AGENDA
PLAN COMMISSION MEETING
Thursday, June 25, 2020 at 7:00 p.m.
Jackson Village Hall
N168 W20733 Main Street
Jackson, WI 53037

STAFF REVIEW COMMENTS
Plan Commission Meeting – June 25, 2020

1. Planned Unit Development Amendment – Premier Rosewood Jackson PR3 – Sign – Rosewood Lane

LARGE PROJECT SIGN

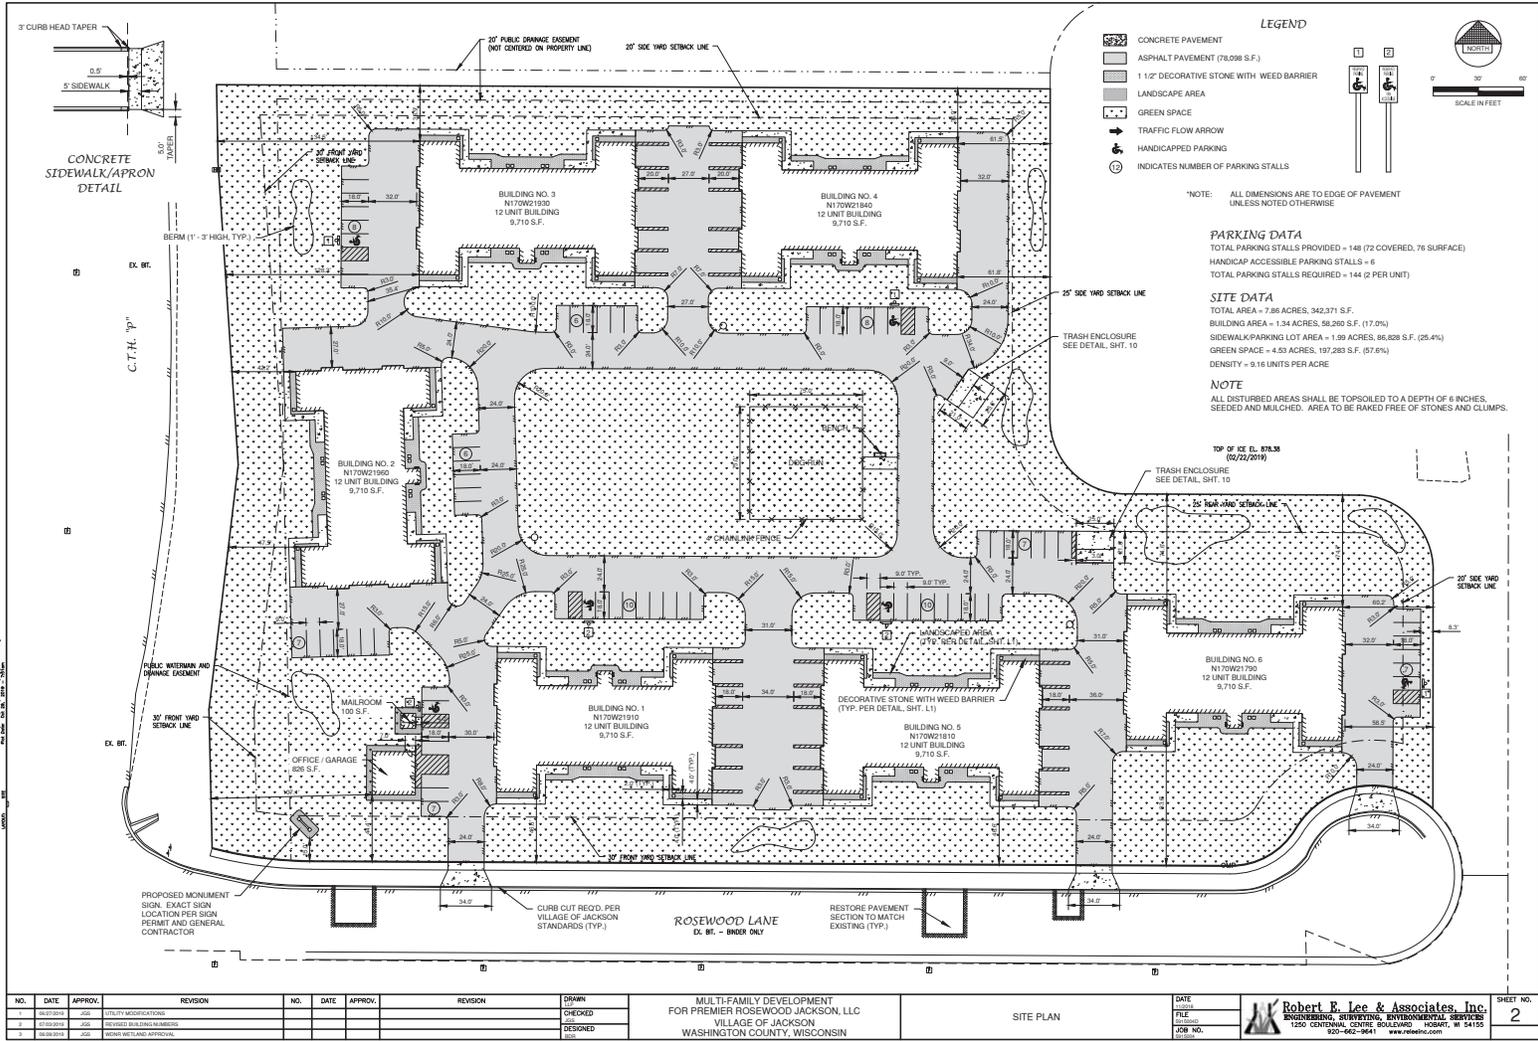
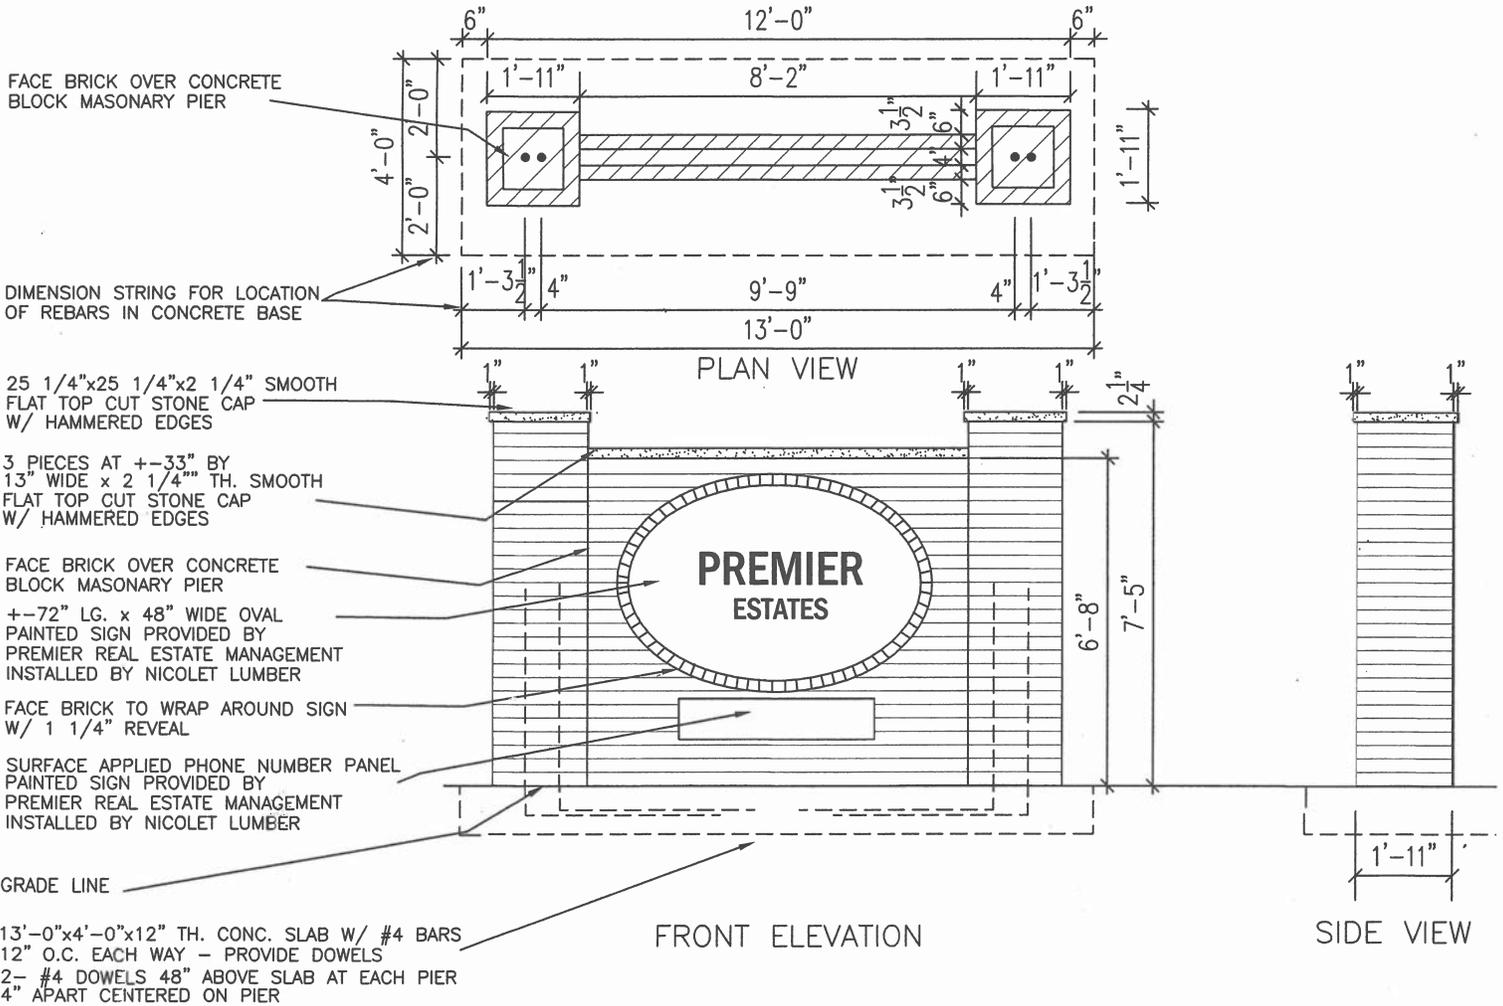
- Sign location indicated on plans is shown within the setback area. Sign should be relocated to comply with setback requirements.
- Plans do not indicate whether sign will be illuminated. Provide clarification on illumination, if any, and type proposed (i.e. back-lit, front, etc.).
- Plan application mentions a landscaping plan was included however; landscaping plans specific to the monument sign were NOT included in the submittal.

- Missing sign landscape plan. Sign should be properly located.

UTILITY PLAN

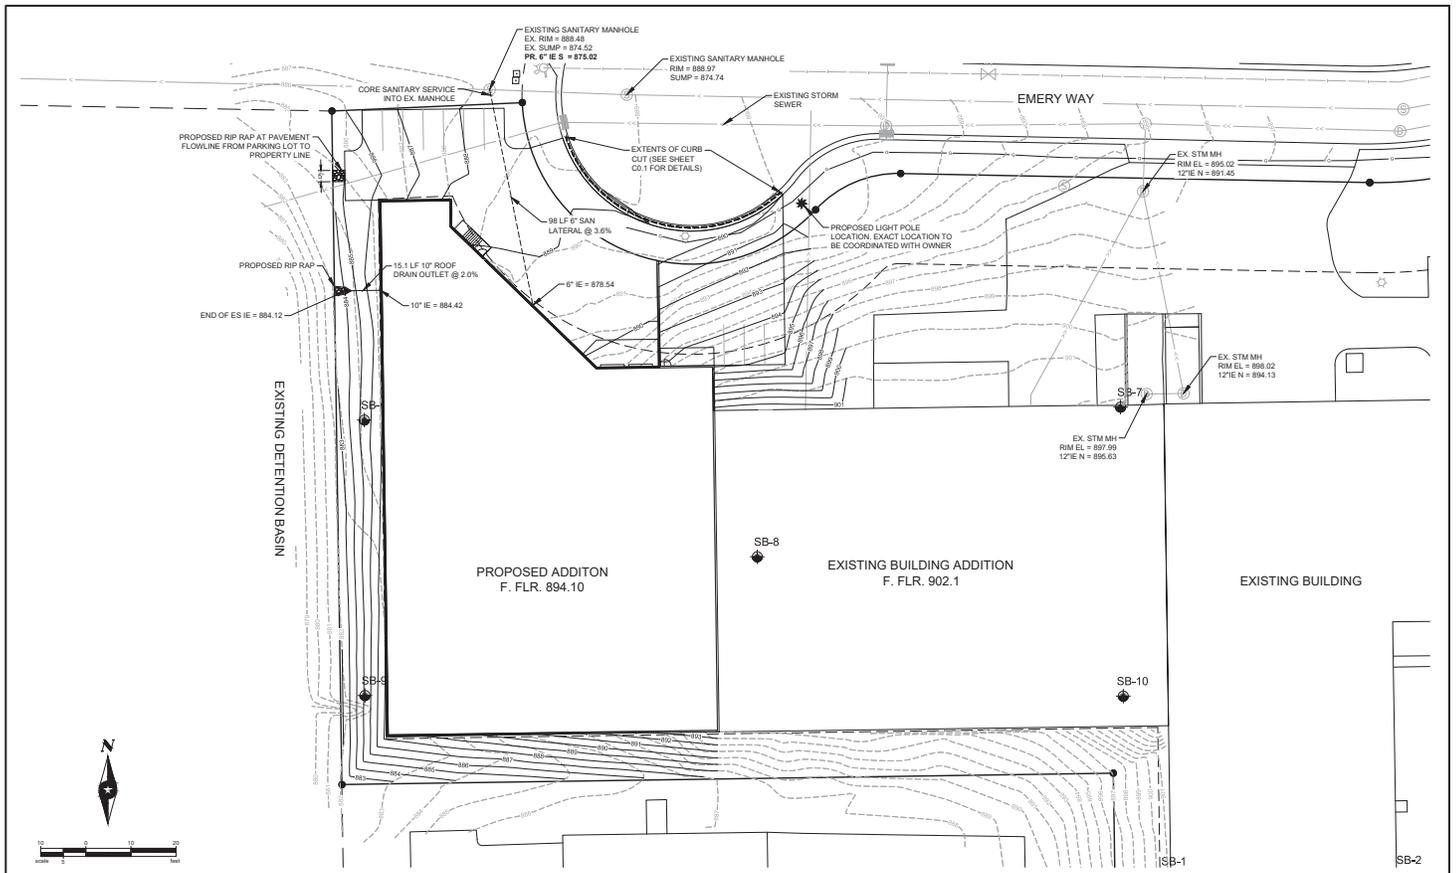
- The sanitary lateral shall discharge into the sewer main and not in the manhole. If the sanitary sewer lateral is only for the new bathroom group, then no sampling manhole is required. If the sanitary lateral is provided for production, then a sampling manhole will be required.
- The Village will allow direct discharge into the regional pond, although, a Stormwater Management Plan shall be submitted with the following criteria: calculation on the pre and post of storm runoff for 2 yr, 5 yr and 100 yr for the addition and the entire site.

1 ARCHITECTURAL SITE PLAN
SCALE: 1" = 40'-0"

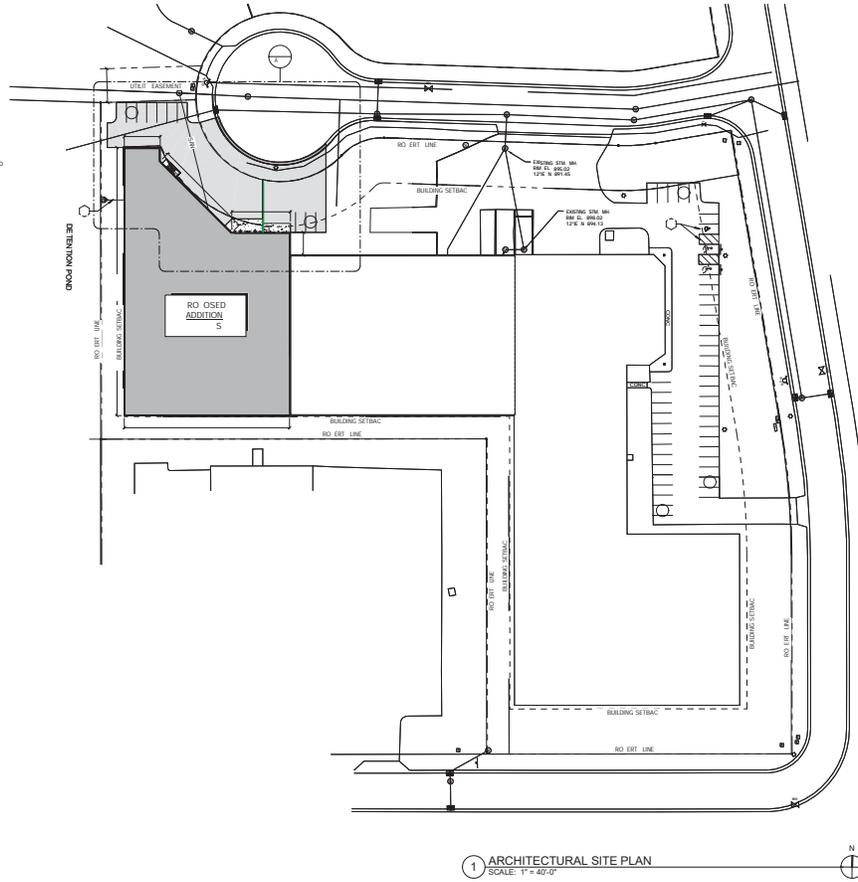
- Plans show pavement/parking and extended approach area proposed for the right-of-way areas abutting Emery Way. Staff discussed this with the owner in a preliminary meeting and has no objections to this. It should be noted that a light pole exists on the south side of the cul-de-sac and would need to be relocated to accommodate the proposed driveway and entry to the new loading docks. Owner to workout potential re-location with WE Energies directly.
